UNITED STATES PATENT AND TRADEMARK OFFICE
CERTIFICATE OF CORRECTION

PATENT NO. : 6,034,135
DATED : March 7, 2000
INVENTOR(S) : David Aaron Schwartz et al.

Column 3,

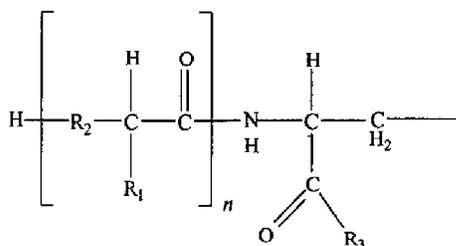
Lines 49-54, that portion of the structure reading "R₃" should read -- R₁ --, as follows:

Column 6,

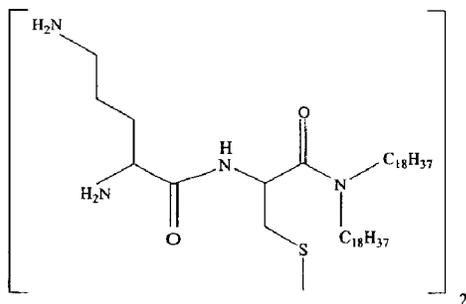
Lines 13-22, that portion of the structure reading "C₁₆H₃₇" should read -- C₁₈H₃₇ --, as follows:
